PARK System Red Ring Around Vehicle During Front or Rear Camera Flap Actuation

Topic number	LI54.71-P-080236
Version	1
Function group	54.71 - Camera and radar-assisted assistance systems
Date	2/2/26
Validity	213 Facelift (Starting model year 2019)
	223
	238
	257
	290
	297
Reason for change

[213M_223_238_257_290 - Camera Door EMF_Rear.png](#)

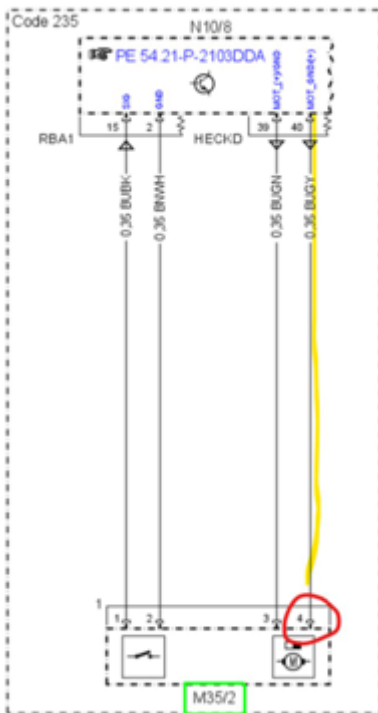
For vehicles with rear facing camera (223, 213 Facelift, 238, 257, 290, 297):

- 213 Facelift, 223, 238, 257, 290 > Install on M35/2, pin 4

File	Description
223_297 - Camera Door EMF_Front.png

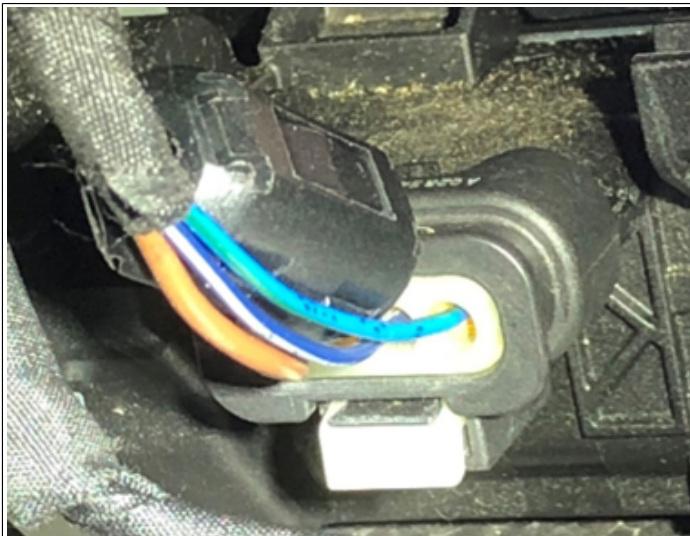
For vehicles with a front facing actuating camera and flap (223 and 297):

- 223, 297 > Install clip on ferrite magnet on M35/1, pin 3.
